**TOWN OF MOUNTAIN VILLAGE
REGULAR DESIGN REVIEW BOARD MEETING AGENDA
THURSDAY JULY 11, 2024, 10:00 AM
MOUNTAIN VILLAGE TOWN HALL
455 MOUNTAIN VILLAGE BLVD, MOUNTAIN VILLAGE, COLORADO
TO BE HELD HYBRID THROUGH ZOOM:**

4.	10:17	30	Nelson/ Applicant	Quasi-Judicial	Consideration of a Design Review: Final Architecture and Site Review for Lot 166AR2-10, 10 Stonegate Dr, pursuant to CDC Section 17.4.11.

PROJECT NAME:
SINGLE FAMILY
LOT 10, STONEGATE
MOUNTAIN VILLAGE, CO

SHEET DESCRIPTION:
HEIGHT CALCS-
EXISTING, AVG. HGT.
SHEET NUMBER

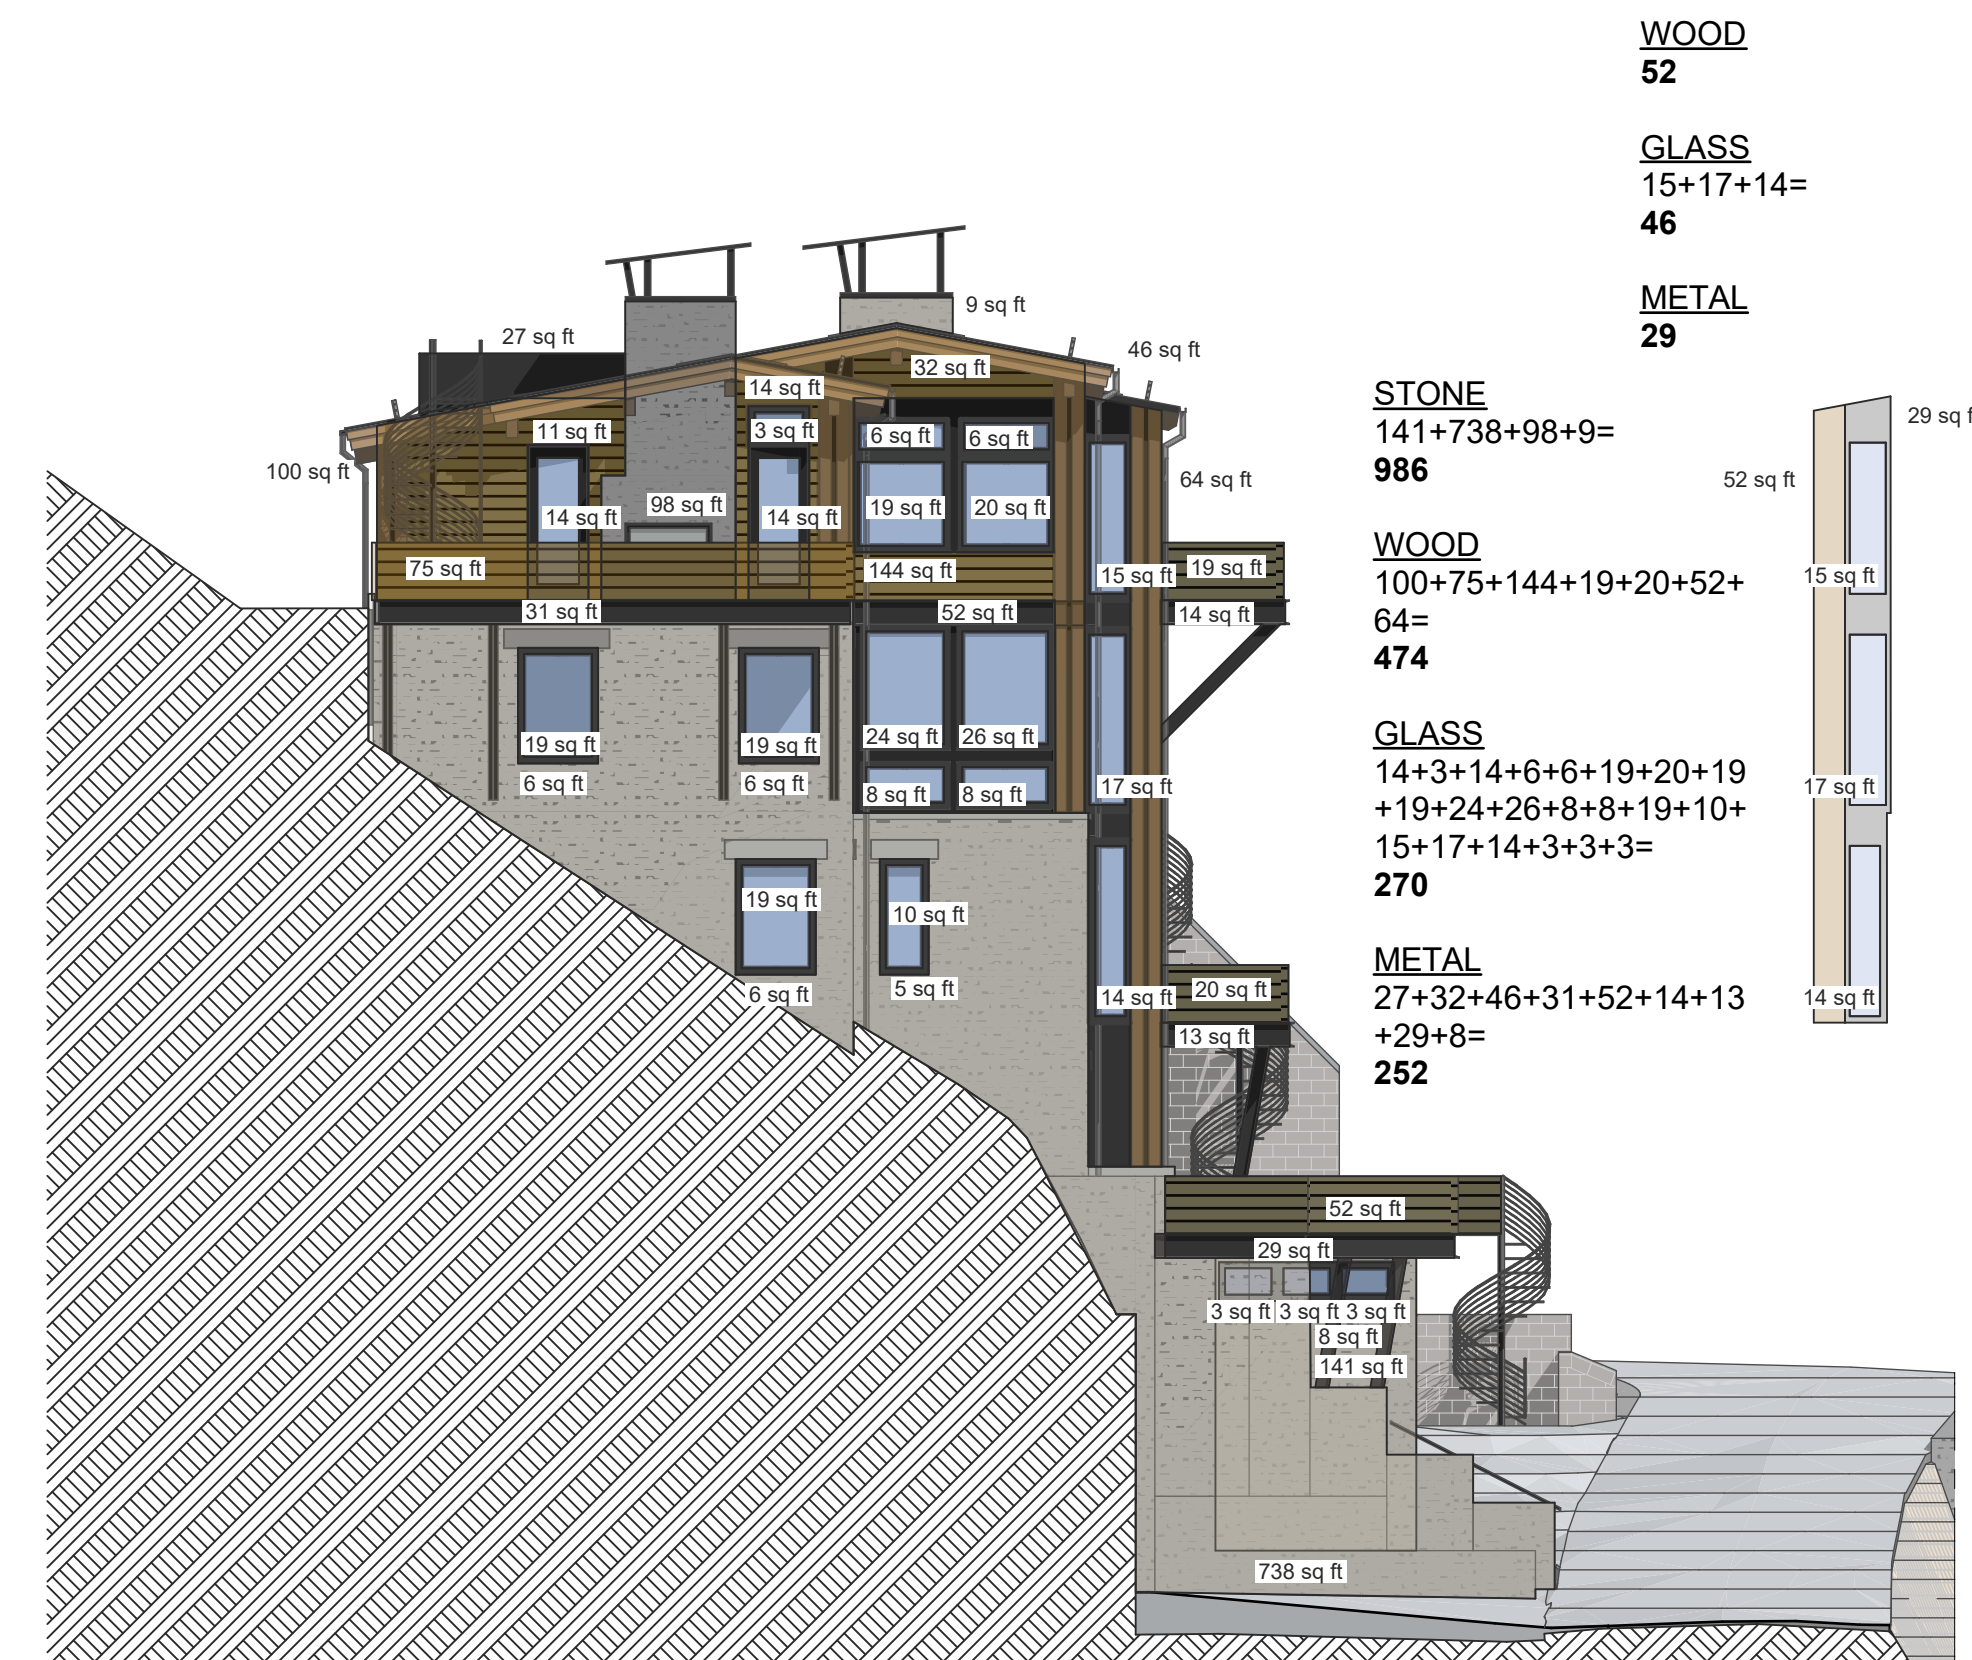
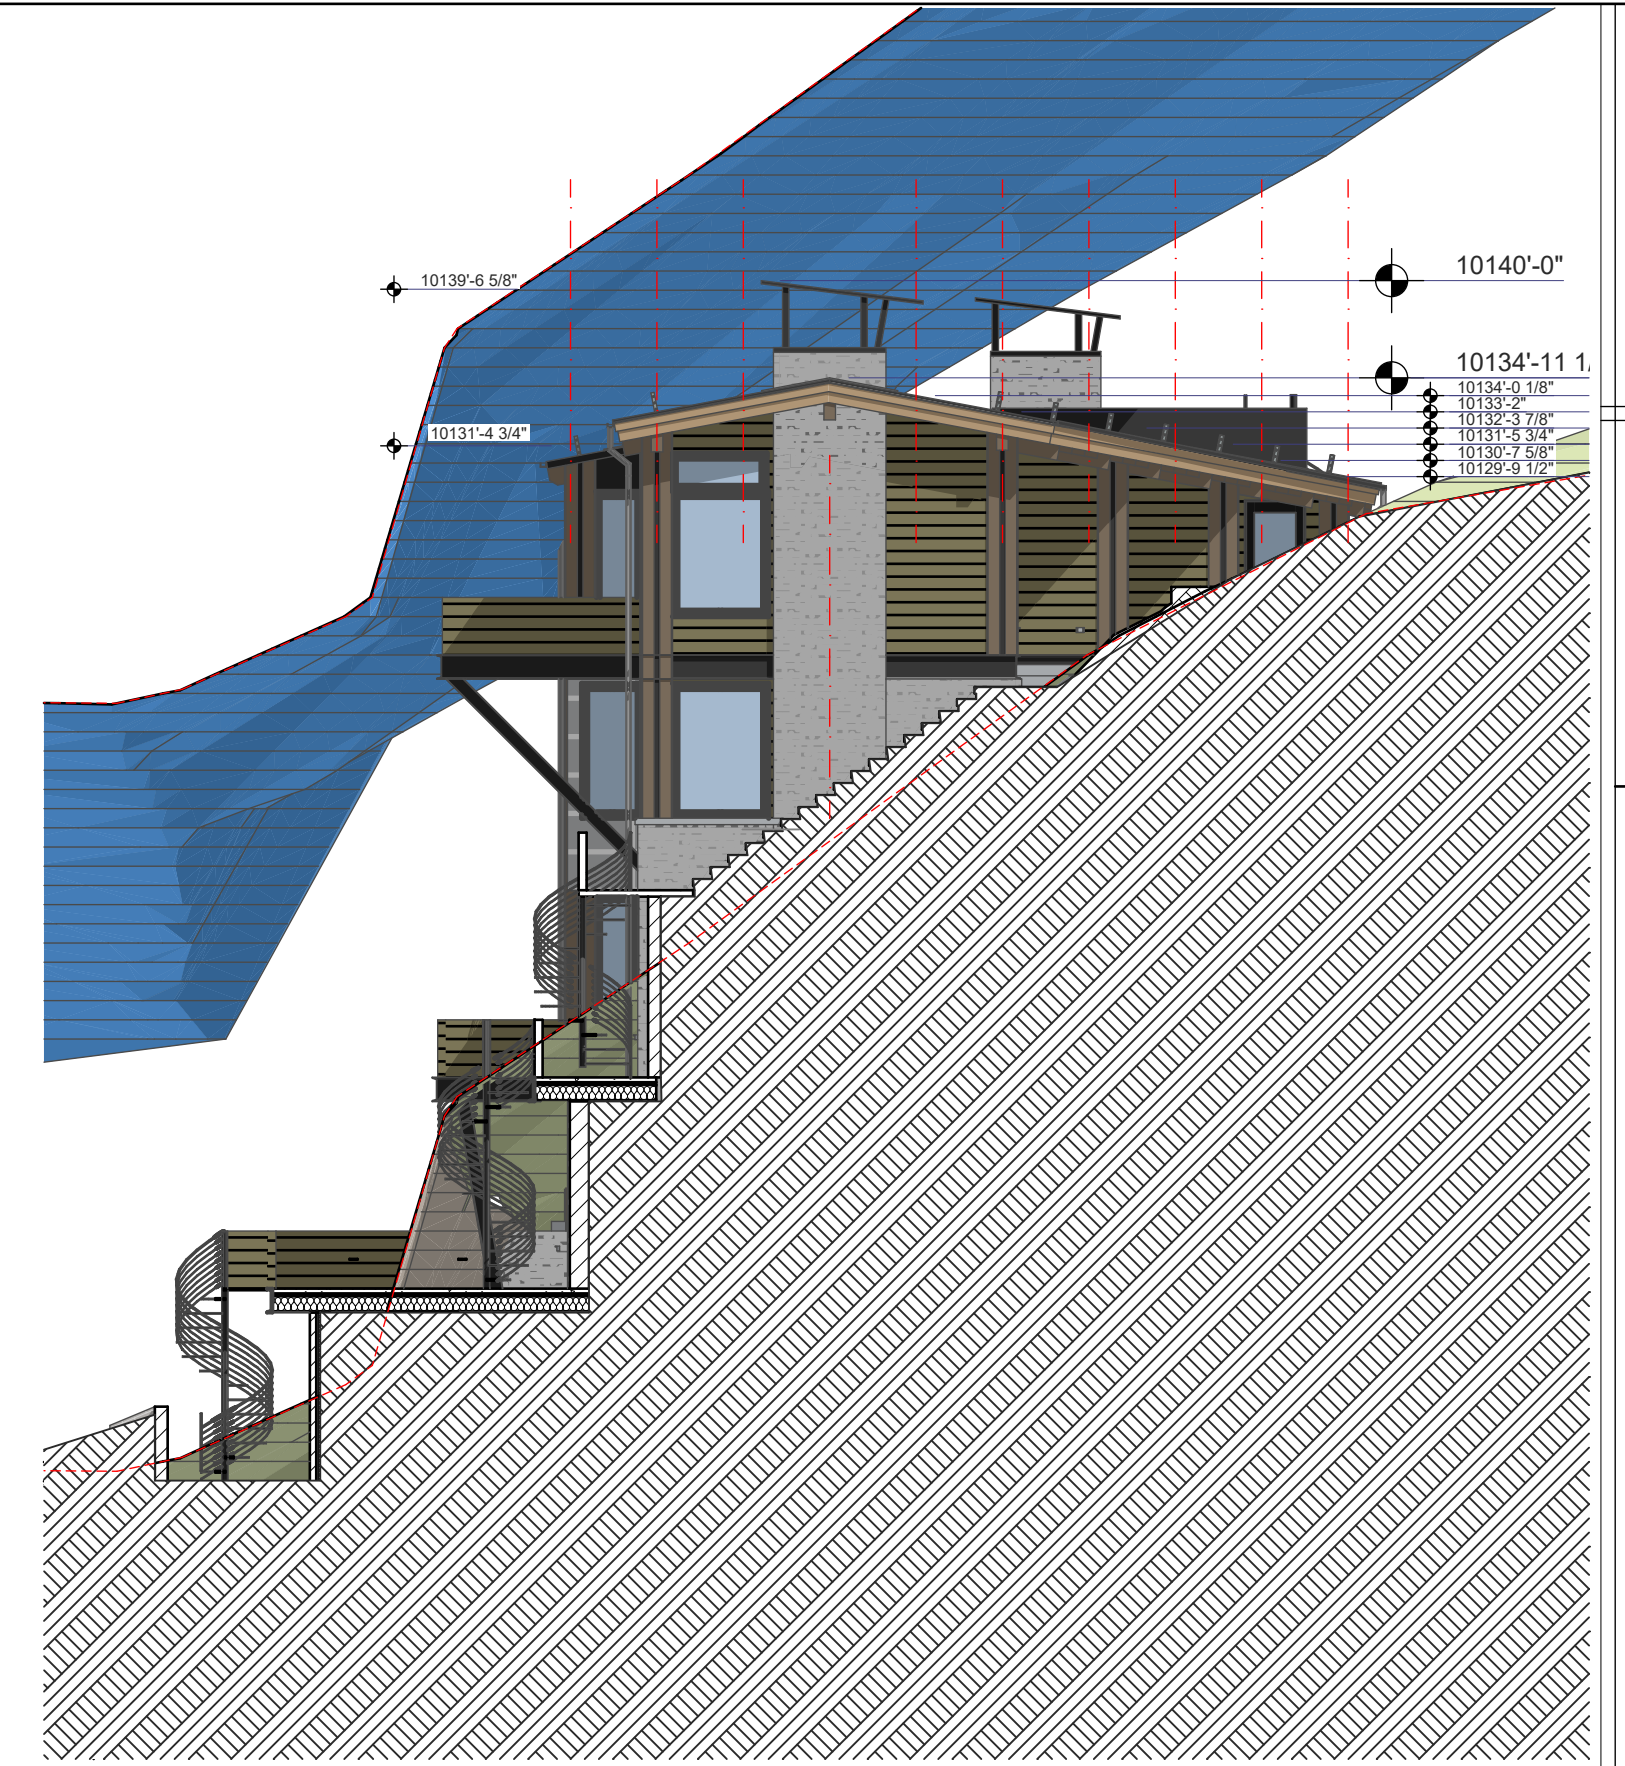
Staff: The primary roof form of the proposed structure is gabled and is therefore granted a maximum height of 40 feet and an average height of 35 feet. The applicant has indicated that the maximum height of the current proposed structure is 45.67 feet and has an average height of 27.59 feet (Sheet A-009 of the attached plan set). The CDC requires that height is demonstrated relative to both existing and proposed grade and that the most restrictive measurements be used to determine height. The Town Council approved a height variance of 6 feet above the maximum at their May 16, 2024 regular meeting.

The subdivision plat for Stonegate also includes a more restrictive plat note for building heights. The plat states that the overall building shall not exceed the USGS elevation of 10,135' and that chimneys shall not exceed 10,140', which the plan set indicates is being met for the home design.

Figures 2-5 show the elevations as they relate to the natural grade of the proposed structure and Figure 6 shows the 40' parallel offset to show portions of the structure above the 40-foot threshold.
